**Eastern CFRAM Study, Accelerated Works Consultation, Synthesis Report
Camac and Poddle HPWs
IBE0600Rp0024**

Eastern CFRAM Study - Poddle Options Report (Section 8)

IBE0600Rp0030

Figure 8.1 - Maintenance areas on the River Poddle

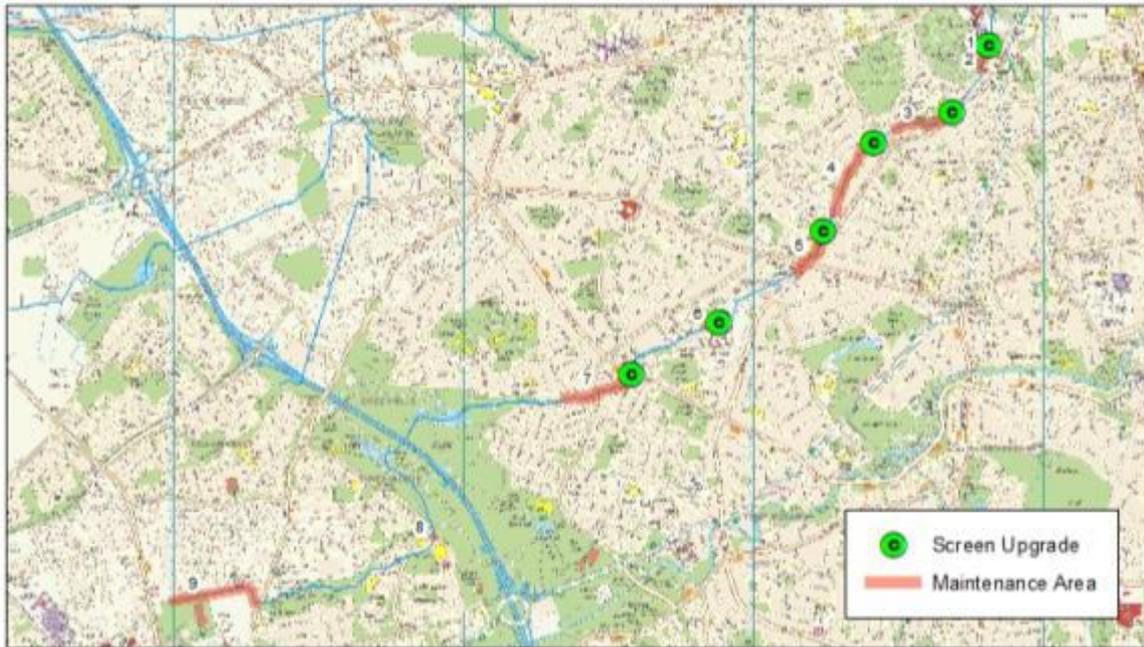
It was highlighted during the consultation process that many members of the public have a perception that there is an ongoing maintenance issue along the River Poddle corridor. Problems with rubbish tipping and debris blocking stretches of the open channel and culverts is indeed a recurring problem. While the impact of rubbish tipping is difficult to quantify, it was appreciated that it is a real risk that had not been managed within the preferred FRM options. It was therefore recommended that maintenance be included to the preferred FRM options.

Due to the urbanised nature of the watercourse, high concentration of flood receptors, and that fact that the river is relatively small, it is particularly sensitive to any restriction in flow. It has been noted that some areas are prone to rubbish tipping which can contribute significantly to the flood risk.

Nine areas have been identified as areas requiring screen upgrades, increased maintenance and monitoring and are detailed in the figure and table below. For most of the areas identified where

Maintenance Issue	Comment	Recommended Action
<p>Area 1</p> 	<p>The culvert at Harold's Cross has been identified as at risk of blocking and causing a significant increased flood risk. DCC currently monitor this culvert remotely using CCTV.</p>	<p>Upgrade screen. Extend head and wing walls to contain the water.</p>

Maintenance Issue	Comment	Recommended Action
<p>Area 2</p> 	<p>Sedimentation and debris appear to accumulate upstream of the Mount Argos Road bridge. However due to the high walls there is a large capacity along this stretch of the watercourse. The flood risk would therefore be considered low.</p>	<p>Monitor this stretch of watercourse.</p>
<p>Area 3</p> 	<p>The culvert leaving Mount Argos Park at Kimmage Road Lower has been identified as at risk of blocking and causing a significant increased flood risk. Debris has been found in the watercourse upstream of Mount Argos Park at Mount Argos Way which may potentially contribute to the culvert blockage risk/</p>	<ul style="list-style-type: none"> • Construct screen. • Extend head and wing walls to contain the water. • Secondary Screen at Mount Argos Way • Increased debris removal from Mount Argos Square to Kimmage Road Lower
<p>Area 4</p> 	<p>The culvert at Sundrive Road has been identified as at risk of blocking and causing a significant increased flood risk. The approach to the culvert consists of open space along St Martin's Drive followed by gardens backing on to the river. There is evidence of debris at the culvert and reports of rubbish tipping in the area. A small screen is located in the open space described upstream of a footbridge.</p>	<ul style="list-style-type: none"> • Upgrade screen has already occurred. • Extend head and wing walls to contain the water. • Upgrade Secondary Screen at open space adjacent to St Martin's Drive. • Increased debris removal from St Martin's Drive to SunDrive Shopping Centre. • Railings along Poddle Park Road to discourage tipping.

Maintenance Issue	Comment	Recommended Action
<p>Area 5</p> 	<p>The culvert at Poddle Park has been identified as at risk of blocking and causing a significant increased flood risk. There have been reports of rubbish tipping at the park and DCC carry out regular rubbish removal.</p>	<ul style="list-style-type: none"> • Construct screen. • Extend head and wing walls to contain the water. • Secondary Screen in Poddle Park has already been constructed. • Increased debris removal in Poddle Park. • Railings along Poddle Park to discourage tipping.
<p>Area 6</p> 	<p>The culvert at Kimmage Manor has been identified as at risk of blocking and causing a significant increased flood risk. The culvert is located between two recently upgraded culvert bypass screens. There is evidence of sedimentation upstream of the culvert</p>	<ul style="list-style-type: none"> • Construct screen. • Extend head and wing walls to contain the water. • Remove sediment and re-profile to ensure self cleansing channel

<p>Area 7</p> 	<p>The reach of watercourse between Wellington Drive (leaving Tymon Park) and Templeville Road was found to have a significant amount of debris. While the flood risk is not significant along this reach it is situated upstream of Whitehall Road and Wainsfort Manor which does. A course screen is located at the Templeville Road culvert but is in disrepair.</p>	<p>Replace course screen and increase debris removal.</p>

Maintenance Issue	Comment	Recommended Action
<p>Area 8</p> 	<p>There is evidence debris blocking the twin culverts at the school and sports complex in Tymon North. The flood risk here however is not significant.</p>	<p>Monitor the culvert inlet.</p>
<p>Area 9</p> 	<p>The reach of watercourse behind the commercial units at Airton Road is heavily vegetated and could restrict flow and raise water levels accordingly. Properties are at risk in this area and the flood risk could increase as a result of heavy vegetation.</p>	<p>Monitor Vegetation</p>
